TOPIC: OVER TENSIONING OF INLET MANIFOLD FASTENERS
LEADING TO GASKET FAILURE

APPLICABLE TO: ALL SANDVIK CAT C7 ACERT EXPLOSION PROTECTED
DIESEL ENGINE SYSTEMS
SANDVIK LS171, LS191 LOADERS

BULLETIN NUMBER: SB1204

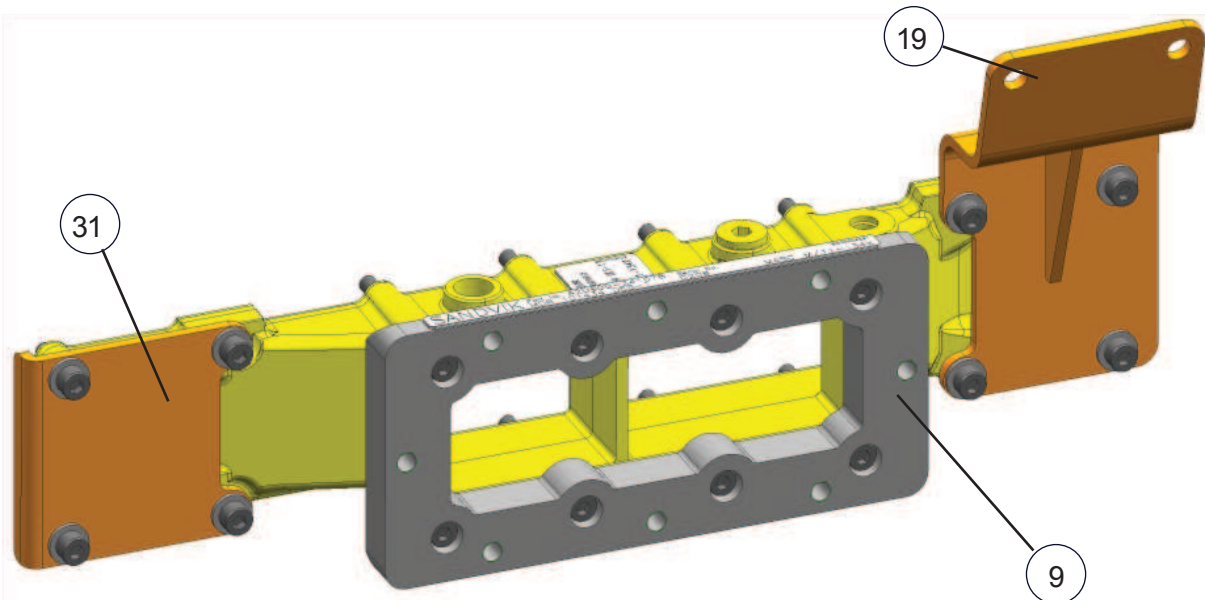
1. Please note the installation of the additional support bracket (31) on the HUEI pump end of the inlet manifold (see image). When installing, make sure the fuel filter bracket (19), inlet manifold adaptor plate (9) and the new longer 40mm SHCS for the ends are in place before commencing the bolt torque procedure.

2. Bolt torque procedure:
 - A. Start the first sequence at 10Nm and work in the numbered pattern (1 to 16) as shown below.
 - B. When you have achieved to above mentioned torque, re-tension them to 15nm using the same pattern as shown above. Then proceed to 20Nm using the same pattern, then to 25Nm. Once all bolts are at 25Nm then repeat the tensioning sequence at 25Nm again to be sure that all fasteners have achieved the full 25Nm of torque.
3. Reinstall remaining components in reverse order to removal. Replace any damaged components. Ensure only new gaskets are used.

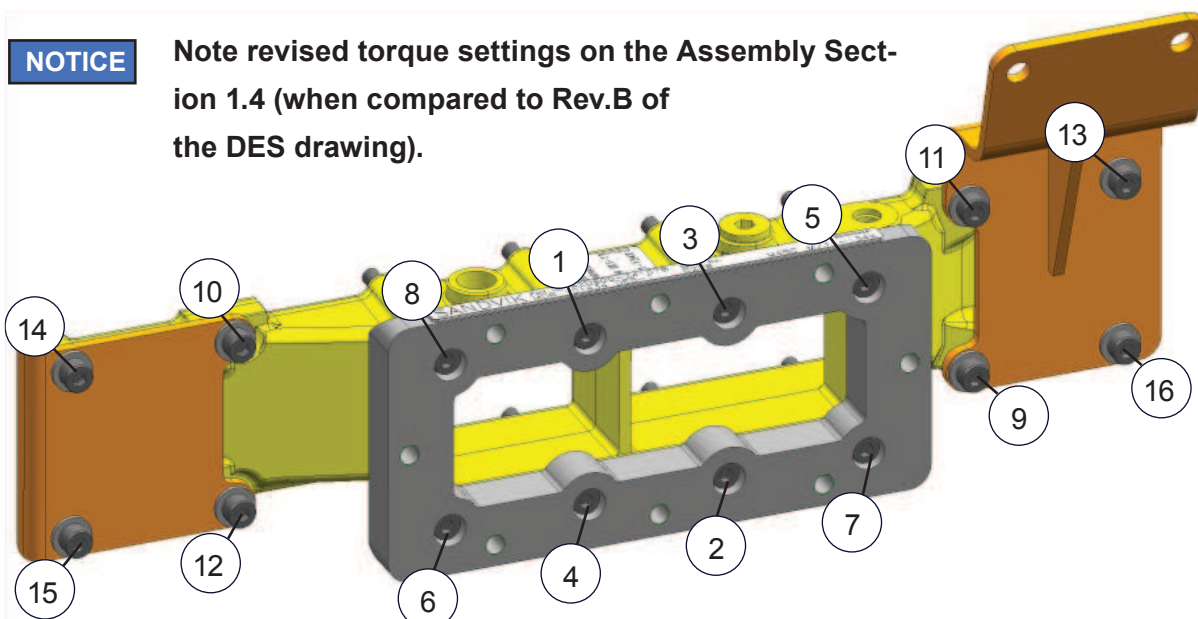
Note revised torque settings on the Assembly Section 1.4 (when compared to Rev.B of the DES drawing).

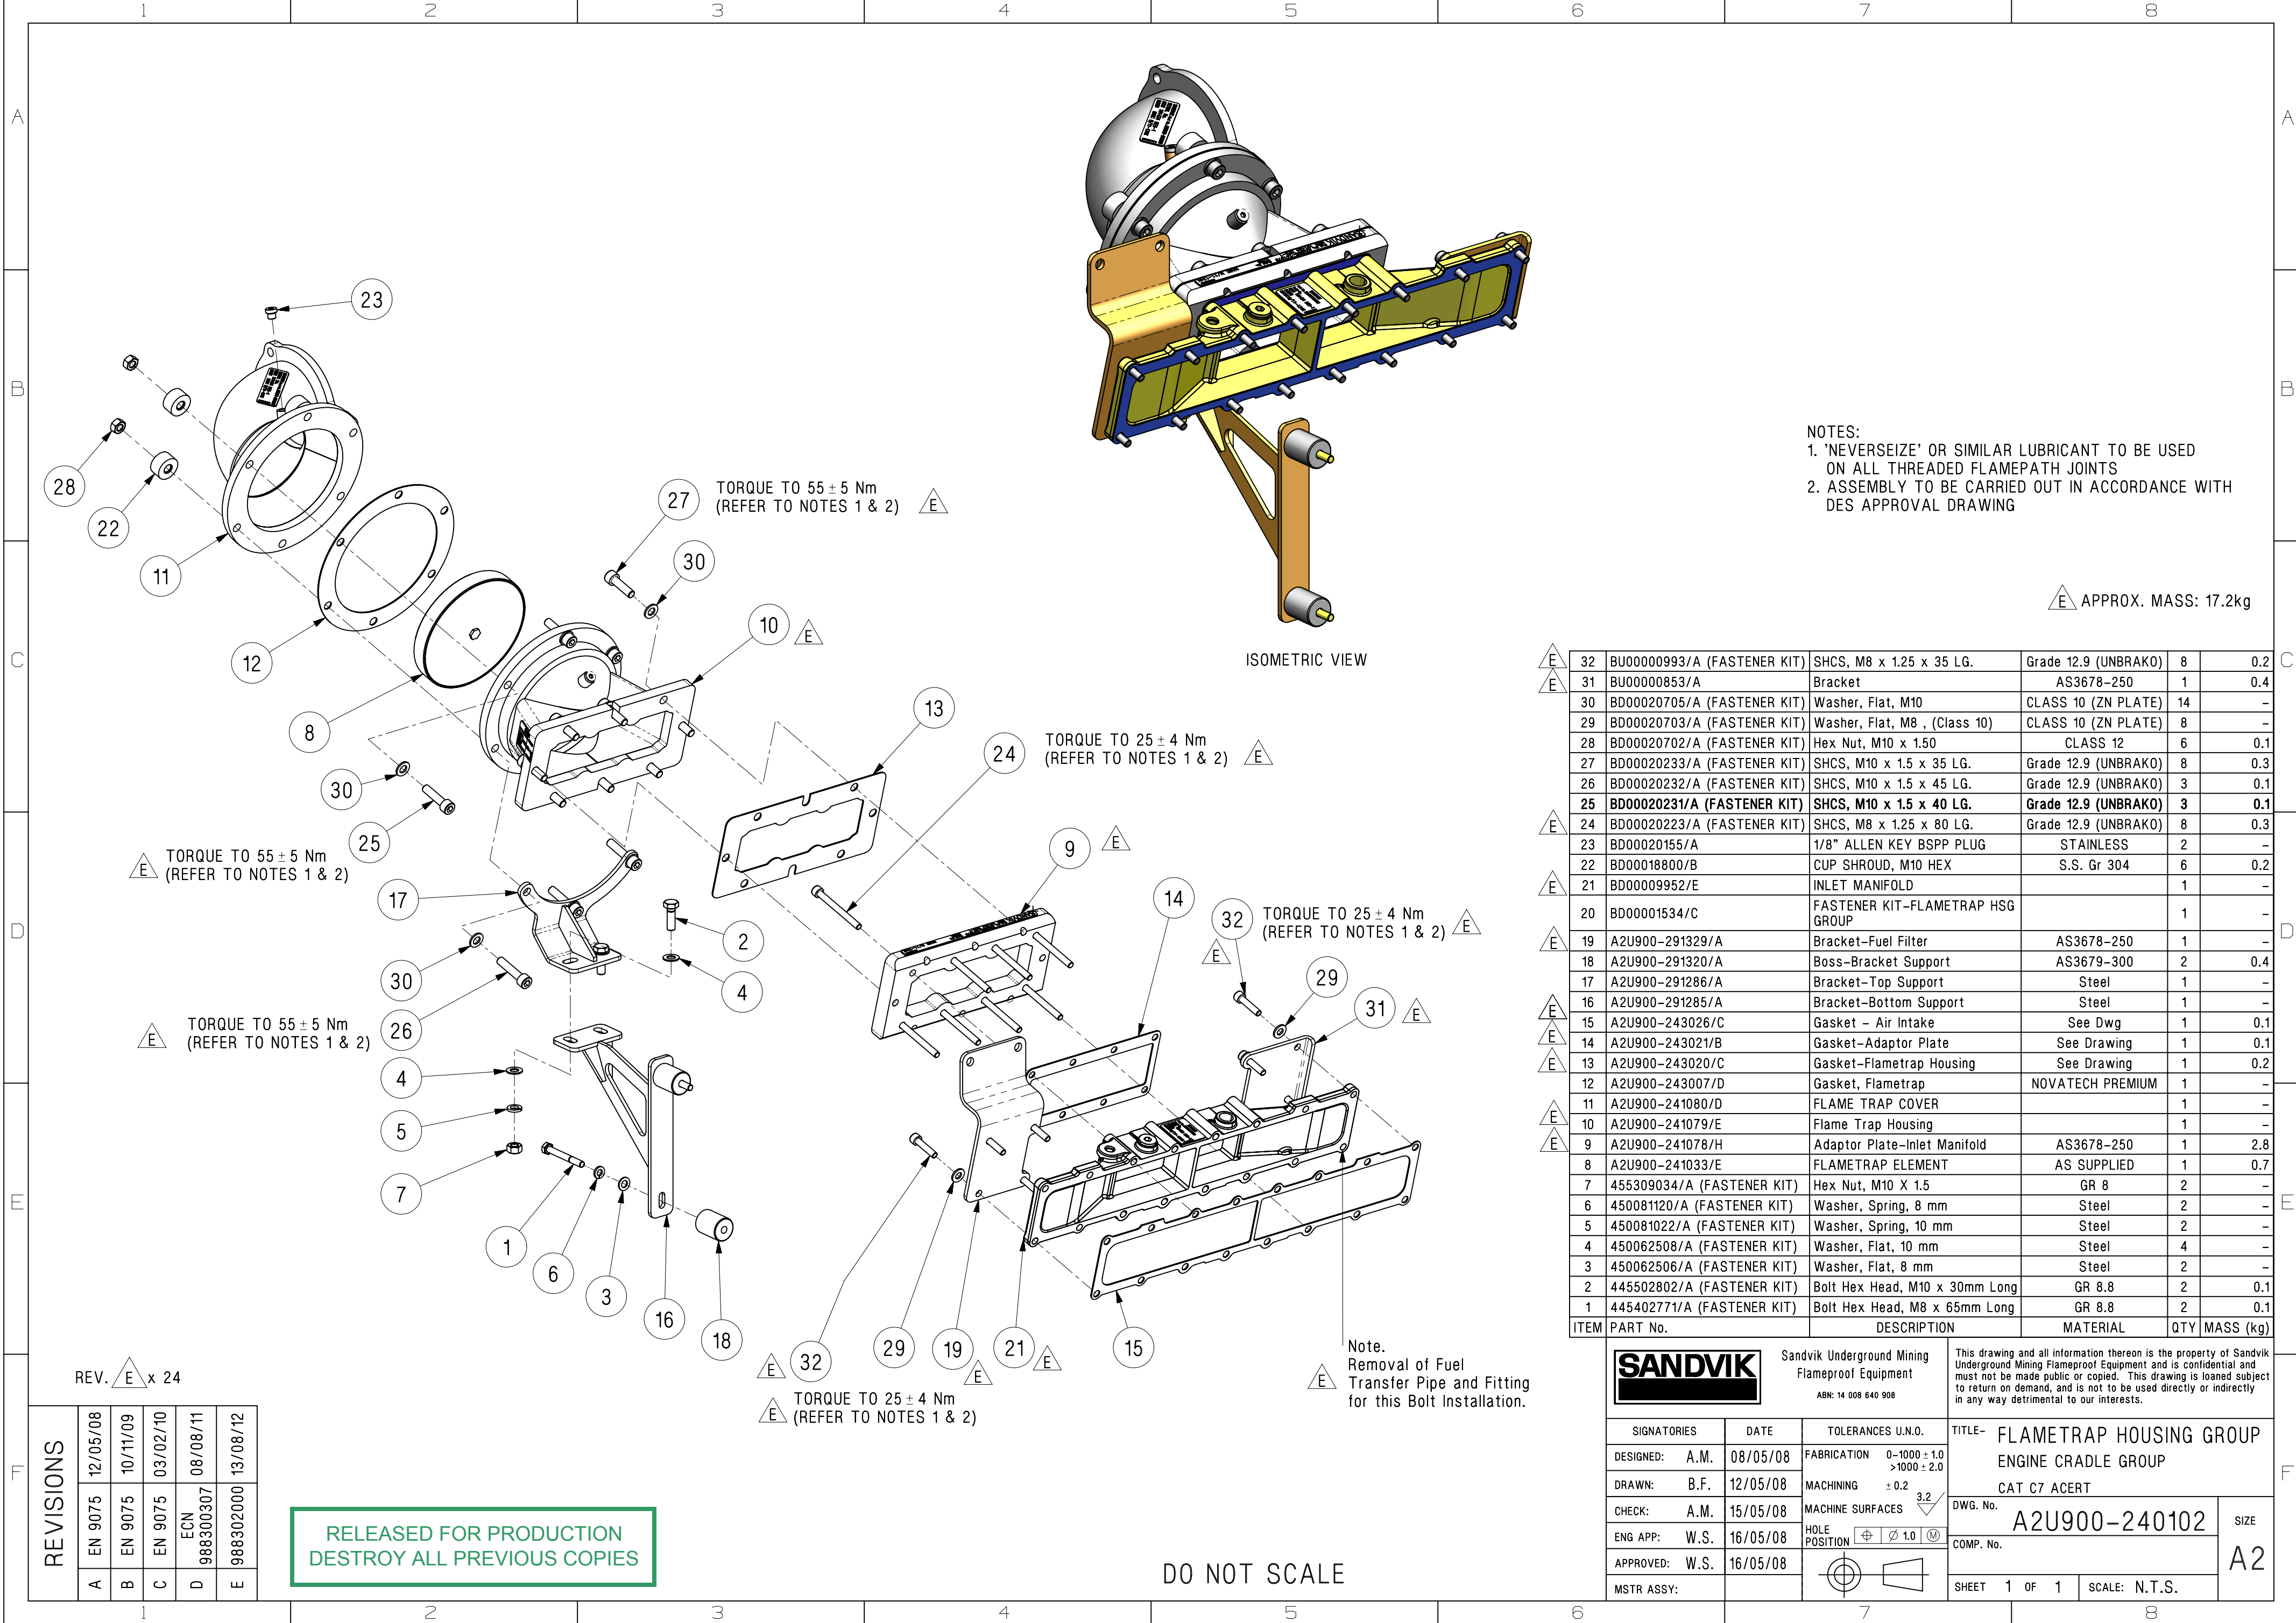
Note.
Removal of Fuel
Transfer Pipe and Fitting
for this Bolt Installation.
